ADDENDUM NO.		1	DATED	4/19/2016		ADDENDUM NO	DATED			
ADDENDUM NO			DATED			ADDENDUM NO		TED		
Number 1	Description Revised NTB No. 6153; Revised Supplement to SP No. 907-618-14; Amendment EBS Download Required.			ement to Download	(Mu:	TAL ADDENDA: _st agree with total addensetfully Submitted,	1 denda issued prio	r to opening of	bids)	
					DV	OW	Contractor			
					BY		Signature			
					TITI	LE				
						ORESS				
					Marie and the second	Y, STATE, ZIP				
				(0)		ONE				
						<u> </u>				
					AIL					
					D IVI					
To be fill	ed in if a corp	oration)								
	Our corporation business addre					e of		and 1	the n	ames,
	Pres	sident					Address			
	Seci	retary					Address			
	Trea	asurer					Address

SECTION 904 - NOTICE TO BIDDERS NO. 6153 CODE: (SP)

SUPPLEMENT TO SPECIAL PROVISION NO. 907-618-14

PROJECT: MP- 6184-34(001) / 305779301 -- Jones County

ADDITIONAL TRAFFIC CONTROL SIGNS REQUIRED:

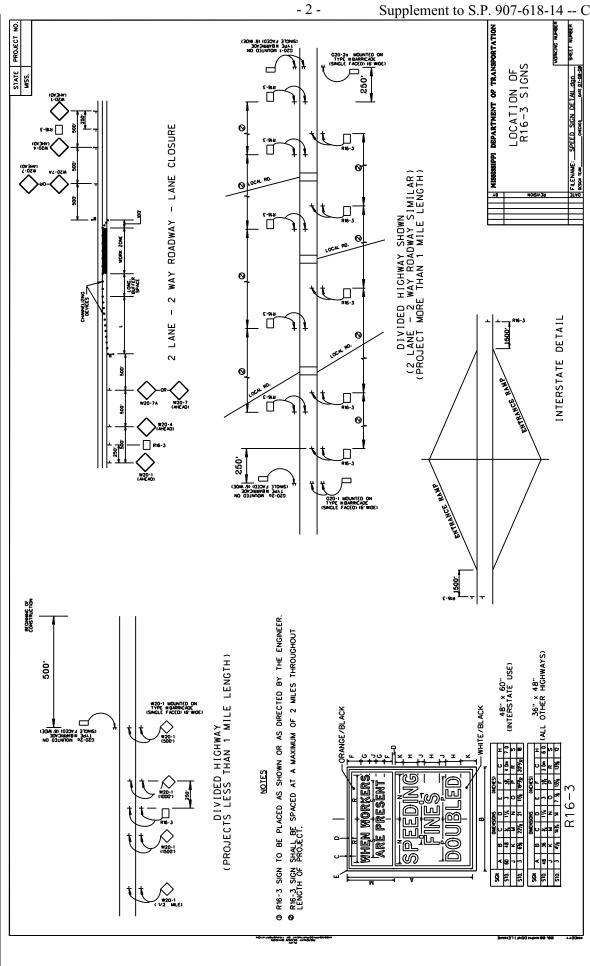
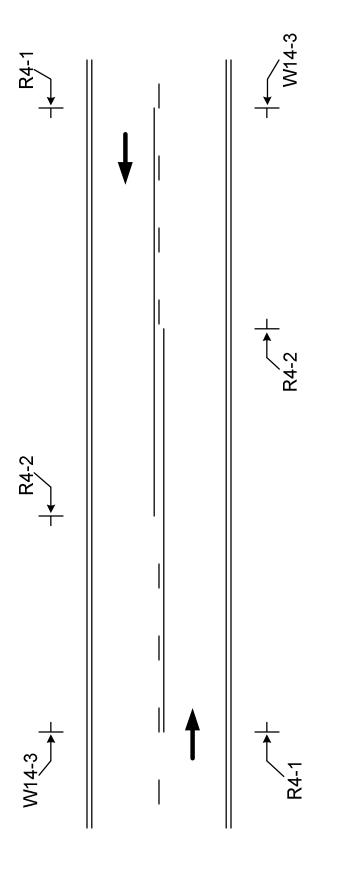
After the first paragraph of Subsection 907-618.01.2 on page 1, add the following.

Additional signs will be required as follows.

- <u>16</u> W20-1 "AHEAD" signs required. One (1) W20-1 "AHEAD" sign is required at each local road or street entering the project.
- 33 R4-1 "DO NOT PASS" signs required.
- 10 R4-2 "PASS WITH CARE" signs required.
- 12 W14-3 "NO PASSING ZONE" signs required.
- 4 R16-3 "SPEEDING FINES DOUBLED" signs required.

R4-1 "DO NOT PASS", R4-2 "PASS WITH CARE", and W14-3 "NO PASSING ZONE" signs are required in accordance with Subsection 618.03.3, this drawing, and as specified in the Manual on Uniform Traffic Control Devices. If no passing zones are 1,000 feet or more, additional "DO NOT PASS" signs shall be installed.

The W14-3, No Passing Zone sign, shall be placed on the left side of the road at the beginning of each no passing zone.

The R4-1, Do Not Pass signs, shall be placed on the right side of the road at the beginning of the no passing zone. Additional R4-1 signs shall be placed right and left in increments of 750 to 1000 feet throughout the length of the no passing zone.

The R4-2, Pass With Care sign, shall be placed on the right side of the road at the end of the no passing zone.
